Access Compliance Report

Public Rights-of-Way

(Curb Ramps)

Intersection ID: 5609	Main Street: HAMILTON_CR	Cross Street: SUNSET_RD	Location: NE
ADA ID: 4A907A9775F7	Ramp Type: Perp	Initial Pass/Fail: Fail	Overall Compliance: No
Severity Score: 21.25			
Codes/Mitigation Info/Possible Solution		Field Measurements/Component Compliance

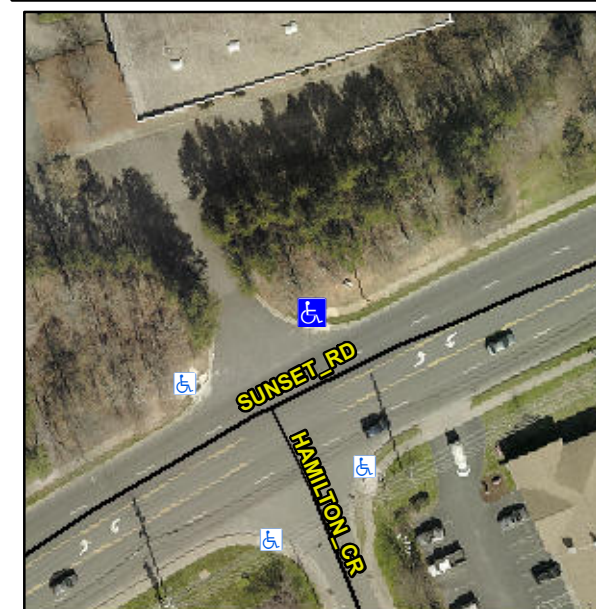
R304.5.1, R304.2.2

Compliance	Description	Data	Compliance	Description	Data
N/A	Ramp Length (in)	49.5	No	Ramp Slope (%)	8.7
No	Ramp Width (in)	45.0	Yes	Ramp XSlope (%)	0.8
N/A	Flare Type LT	N/A	N/A	Flare Type RT	N/A
N/A	Flare Slope LT (%)	N/A	N/A	Flare Slope RT (%)	N/A
N/A	Flare Traversable LT?	N/A	N/A	Flare Traversable RT?	N/A
N/A	Landing Length (in)	N/A	N/A	DWS Provided?	N/A
N/A	Landing Width (in)	N/A	N/A	DWS Contrast?	N/A
N/A	Landing Slope (%)	N/A	N/A	DWS Length (in)	N/A
N/A	Landing X Slope (%)	N/A	N/A	DWS Full Width?	N/A
N/A	Landing Curb? (Y/N)	N/A	N/A	DWS Offset (in)	N/A
N/A	Shared Landing?	N/A			
N/A	Gutter Ponding?	N/A	N/A	Gutter Slope (%)	N/A
N/A	Gutter Lip Ht (in)	N/A	N/A	Gutter X Slope (%)	N/A
N/A	Painted X Walk1?	No	N/A	Painted X Walk2?	N/A
	X Walk 1 Direction	To S		X Walk 2 Direction	N/A
N/A	X Walk 1 Width (in)	N/A	N/A	X Walk 2 Width (in)	N/A
	X Walk 1 Slope (%)	0.9		X Walk 2 Slope (%)	N/A
	X Walk 1 X Slope (%)	4.0		X Walk 2 X Slope (%)	N/A

Remove & Replace Entire Ramp.
